# UNITED STATES PATENT AND TRADEMARK OFFICE

APPLICATION NO.	FILING DATE	FIRST NAMED INVENTOR	ATTORNEY DOCKET NO.	CONFIRMATION NO.
10/544,285	08/03/2005	Wolfgang Kentner	2003P00255WOU'S	1328
7590 12/04/2008				
John T Winburn BSH Home Appliances Corporation 100 Bosch Blvd New Bern, NC 28562			EXAMINER CORRIGAN, JOSEPH JAMES	
			ART UNIT 3744	PAPER NUMBER
			MAIL DATE 12/04/2008	DELIVERY MODE PAPER

### Office Action Summary

## **DETAILED ACTION**

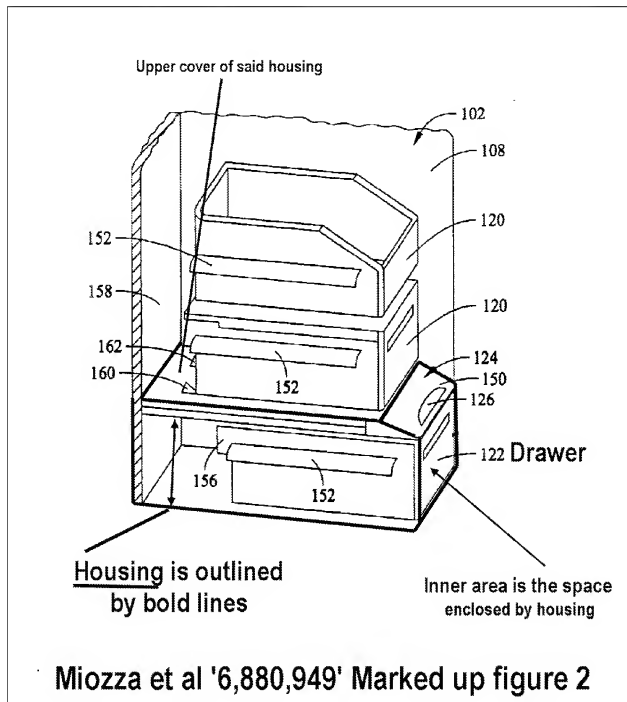
In re claim 14, Miozza et al disclose a refrigeration appliance, comprising: a housing (see marked up figure 2); said housing enclosing an inner area (122, figure 2); said inner area enclosed by a door (136, figure 1); a carrier module (figure 7) located in said housing (see marked up figure 2); and said carrier module including a control circuit (174, figure 3) for controlling (via 172, figure 3) the refrigerating capacity of the refrigeration appliance (figure 1) in said inner area (122, air space within pan, figure 2) depending on a temperature measuring signal (see temperature sensors recited in C4, L21) related to the temperature in said inner area (122, air space within) (see C8, L28-

In re claim 15, Miozza et al disclose the invention above and further disclose a compartment (124, C7, L10) for said carrier module (figures 6-8, C9, L40-47) formed in an upper cover (see marked up figure 2) of said housing (see marked up figure 2).

In re claim 16, Miozza et al disclose invention above and further disclose said cover (210) designed as a side plate (see figure 2, upper cover portion) forming the upper portion of the housing exterior (see marked up figure 2).

In re claim 27, Miozza et al disclose the invention above and further disclose a refrigeration appliance, comprising: a housing (see marked up figure 2); said housing enclosing an inner area (122, space within); said inner area enclosed by a door (136); a compartment formed in an upper cover of said housing, and a carrier module (figure 6) located in said housing compartment (see marked up figures 2); and said carrier module including a control circuit (174, figure 3) for controlling (via 172, figure 3) the
